Firvale Wilderness Camp
4330 Highway 20
Firvale, BC

April 28, 2022

Re: Ratcliffe Creek Stream Channel Remediation
Construction Review

RATCLIFFE CREEK CHANNEL REMEDIATION
FIRVALE WILDERNESS CAMP, FIRVALE, BC
FIGURE 1

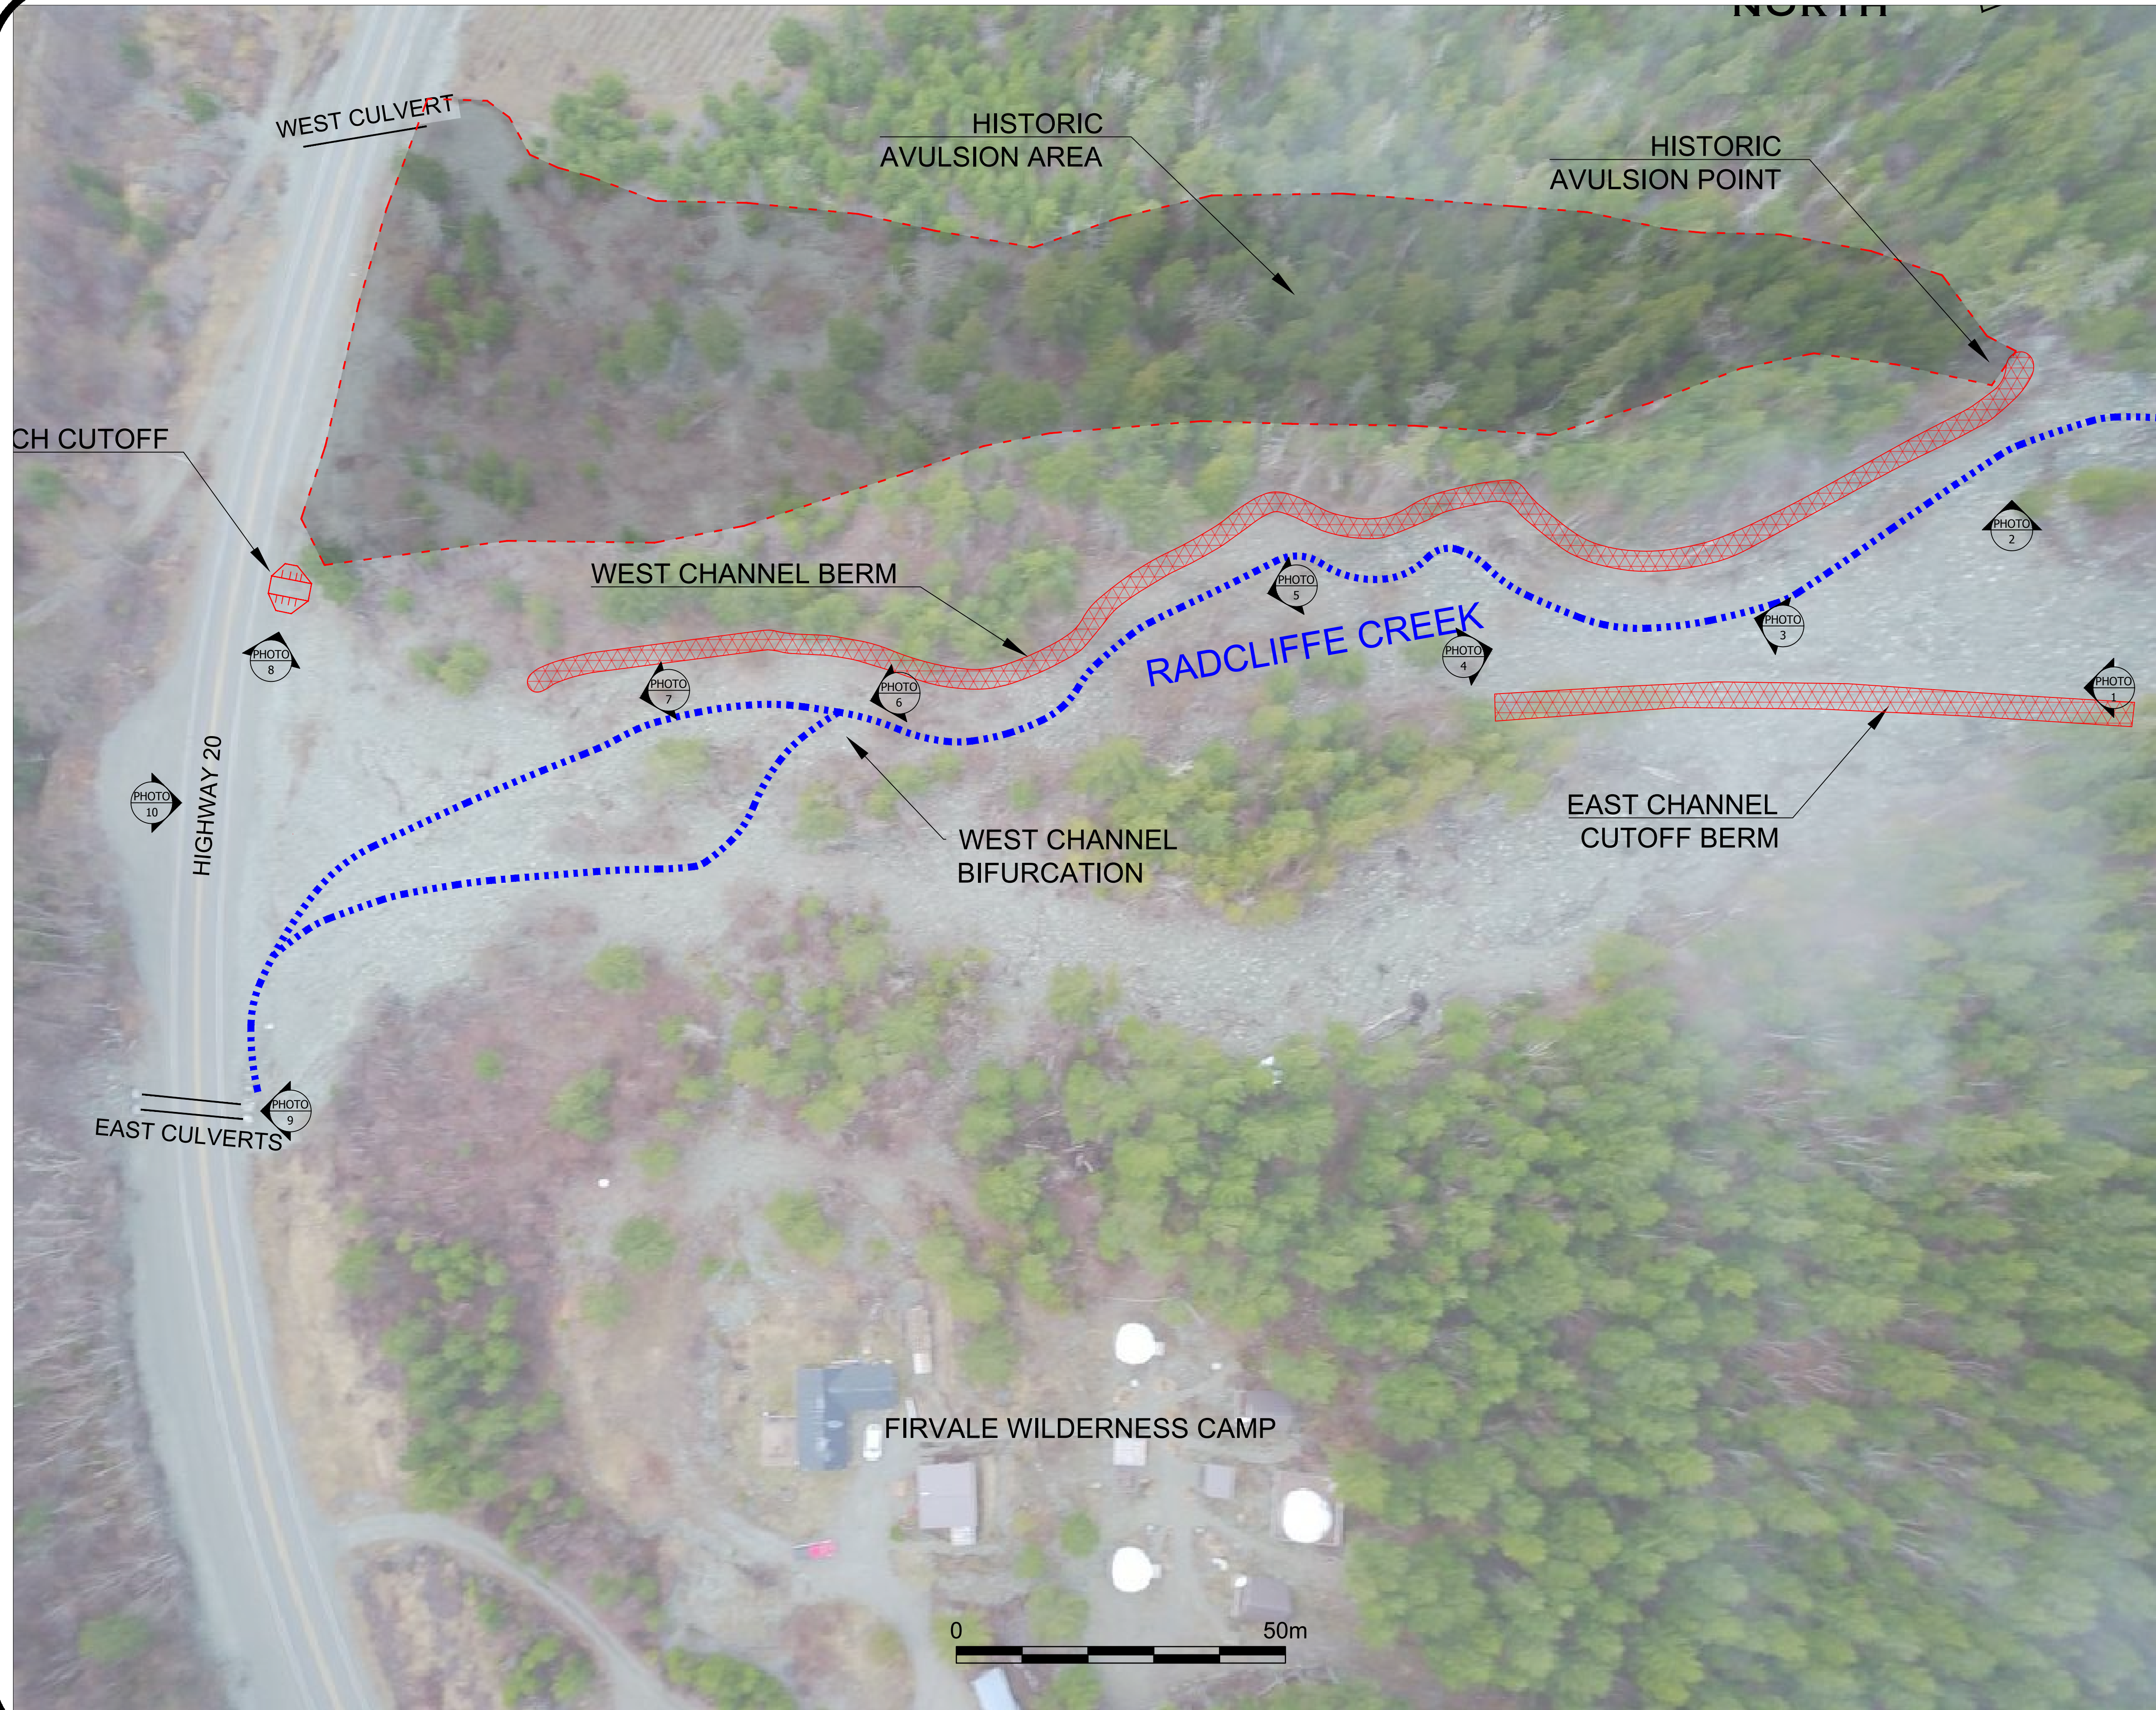
Photos are presented in the Appendix with their locations and orientation referenced in Figure 1.
